Car Stereo
Service Bulletin

Model: XR-7150/7200

No. 140

Subject: Erratic Ejection

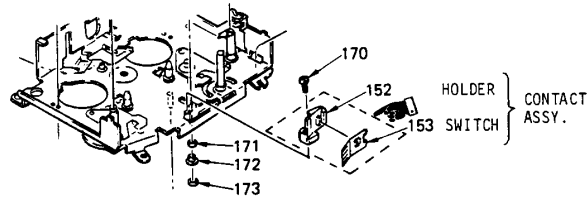
Cassette is ejected just after loading or while changing direction. This is caused by poor S10 switch contact caused by dust or deformation of the contacts.

Solution: Replace the "SWITCH" and "HOLDER" with new ones, as an assembly. The color of the old holder is white, while the color of the new holder in the assembly is black.

Ref. No.	Description	Part Number
152	Contact Holder	A-3239-952-A
153	Switch Contact
